INDESIT company

Model type:
WITE127EU

Commercial code:
F034282

n1040345: Replacement of drum lock button TL EVOII.

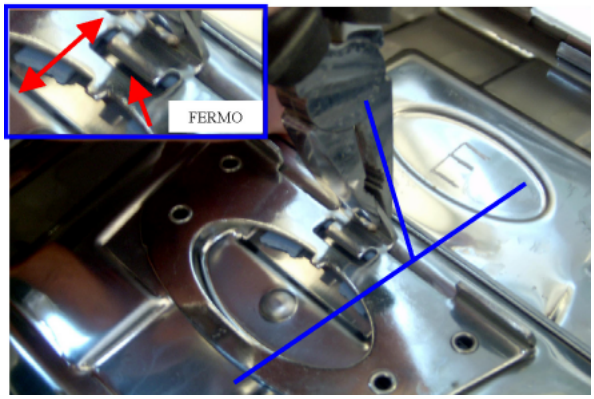
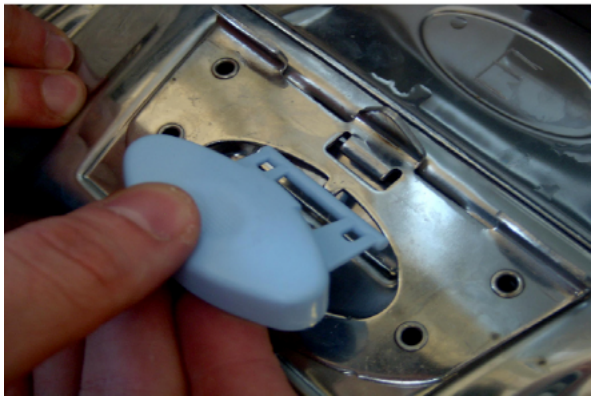
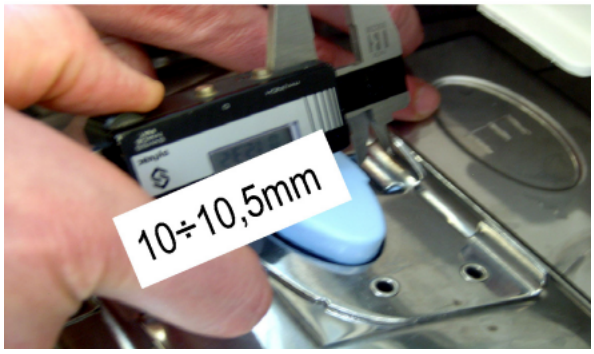
1) turn the central tip of the catch in the direction shown (FIG.1);

2) bring the tip to a vertical position and ensure that the broken button is disengaged from the catch restraint and can be removed (FIG.2);

3) remove the remaining part of the button with the aid of a screwdriver, taking care not to scratch the doors (FIG.3);

4) pre-assemble spring to button (FIG.4);

5) insert button between catch and door (FIG.5);

6) bring the button into position and arrange the spring in its location in the door (FIG.6);

7) turn the central tip of the catch in the direction shown to return it to its starting position (FIG.7);

8) check the distance between button and catch (FIG.8);

9) check correct operation of the button when opening and closing the doors (slight inclination errors of the catch can result in faulty closing of the doors) (FIG.9).

n1040382: Drain pump with bayonet-style filter - top Loading Brembate

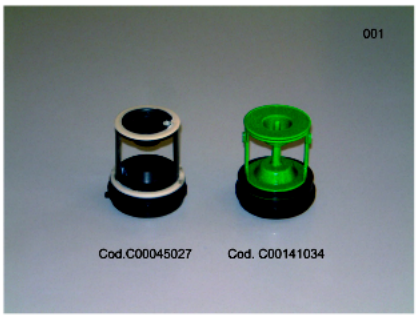
From serial no. 51021.0001 a new drain pump with bayonet-style filter has been installed on all top loading washing machines manufactured in Brembate.

New parts:
C00141862 - Drain pump
C00141034 - Pump filter kit

Premodification parts:
C00111409 - Drain pump
C00045027 - Pump filter kit

The new parts can be used instead of premodification ones.

N1040404FIG1

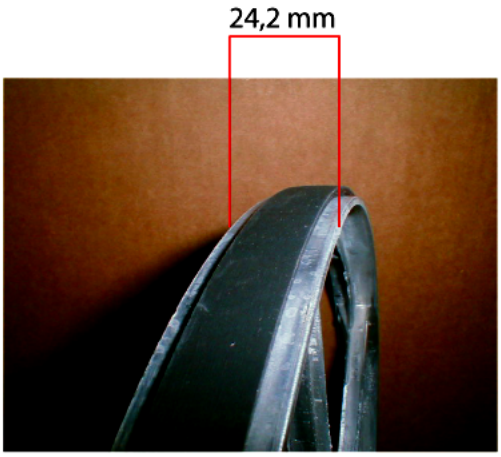
From serial no. 70122.0001 the pulley track has been widened from 21.2mm to 24.2mm (see picture N1040404FIG1).

new pulley
C00142832 - D280 24.2 mm track

Premodification pulley
C00083912 - D280 21.2 mm track

The new pulley can also be used on premodification versions of the models referred to in this release.
